# UNITED STATES PATENT AND TRADEMARK OFFICE

APPLICATION NO.	FILING DATE	FIRST NAMED INVENTOR	ATTORNEY DOCKET NO.	CONFIRMATION NO.
09/347,690	07/02/1999	MANPREET S. KHAIRA	884.107US1	4194
21186	7590	10/03/2005		
SCHWEGMAN, LUNDBERG, WOESSNER & KLUTH 1600 TCF TOWER 121 SOUTH EIGHT STREET MINNEAPOLIS, MN 55402			EXAMINER CRAIG, DWIN M	
			ART UNIT 2123	PAPER NUMBER

**Office Action Summary**

## DETAILED ACTION

Figure 1: An example of overlapping fanin cones

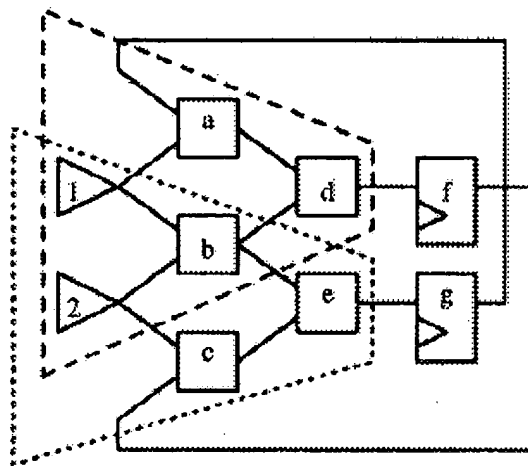
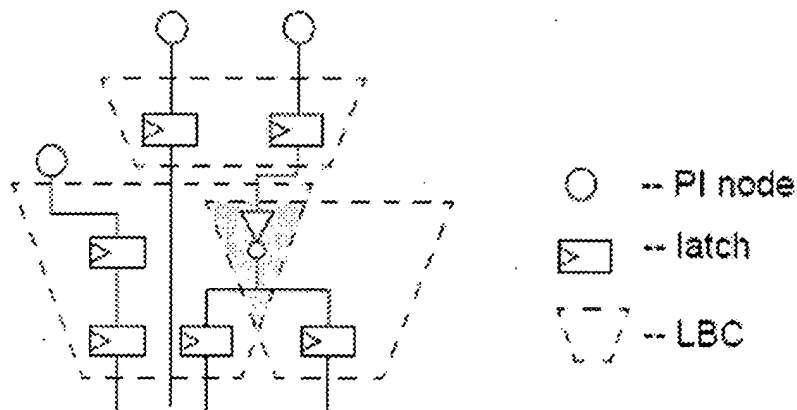
The Examiner notes that above description and figure is a description of an “*extended boundary latch component*” which is clearly defined and disclosed in Applicants’ specification on pages 3, 4 and 5 of the specification and Figures 1 and 3A, 3B and 3C. More specifically the Applicant has provided the following figure,

The Examiner further notes that in the paper entitled “Logic Verification of very large circuits using Shark” which the Applicants’ have sworn behind in an Affidavit under 37 CFR § 1.131 discloses the definition of a Latch Boundary Component on page 312 as, “An LBC is a fanin cone that starts from latches or primary outputs (Pos) and ends at latches or primary inputs (PIs). Figure 3 shows an LBC decomposition of a circuit with overlapping circuitry.” The Examiner can find no difference between the expressly claimed limitations in Applicants’ current claim language, specifically and in regards to a “*Latch Boundary Component*” as claimed and the disclosed elements as cited in the *Manjikian et al.* reference.
